A RESOLUTION OF THE COUNCIL OF THE CITY OF SAN DIEGO ADOPTING AN ADDENDUM TO PROGRAM ENVIRONMENTAL IMPACT REPORT SCH NO. 2021070359 AND ADOPTING THE AMENDED MITIGATION, MONITORING AND REPORTING PROGRAM FOR THE COLLEGE AREA COMMUNITY PLAN UPDATE.

SUBJ: College Area Community Plan Update, 2nd Draft

The College Area Community Planning Board (CACPB) thanks you for this opportunity to offer comments on the 2nd Draft of the College Area Community Plan Update (PLAN). The CACPB has no objection to revising our existing community plan in a manner that supports the future needs of our community over the next 30 years. In anticipation of the City's need to update our PLAN, the CACPB undertook an effort to offer ideas for how anticipated future growth could be reasonably accommodated in the College Area community. Thus, we worked to create a 7-Visions Plan as our contribution towards providing local insight to City officials.

COLLEGE AREA COMMUNITY PLAN UPDATE 2nd DRAFT HOUSING UNIT/POPULATION INCREASES VS. RECENT SAN DIEGO CPUs 9/8/25

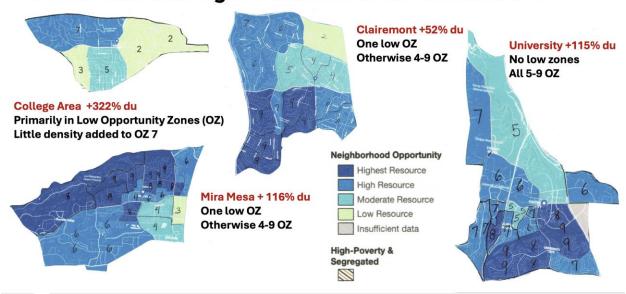
Thus, the CACPB is surprised and disappointed to find that the 2nd Draft of the College Area PLAN still proposes far more capacity than was envisioned by the 7-Visions Plan and far more than is supported by SANDAG's projections. The PLAN proposes 34,150 total dwelling units, which represents a growth rate of 322% in capacity, triple the growth rate that other communities have been asked to bear. This draft allows for a 277% increase in the College Area's population, over three times the population increases that other community plan updates, on average, have planned for.

First, the College Area is not a transit rich environment. While there is a trolley line with two stations in our community, neither of them offers parking for autos that allow a seamless transition between modes of travel. The Trolley only provides direct access to one employment center (downtown, which accounts for only 4.9% of San Diego jobs). The travel time between SDSU and downtown is a reasonable 30 to 40 minutes, but all other job centers require multiple transfers and an average of 90 minutes travel time, not counting access time to and from the stations. The area has many buses, but only one that goes to a job center (215), also downtown, and takes 45 minutes not including access to or from the transit stop. Getting to any other major employment center takes 70-90 minutes plus access time to and from transit, translating to a 3–4-hour daily commute.
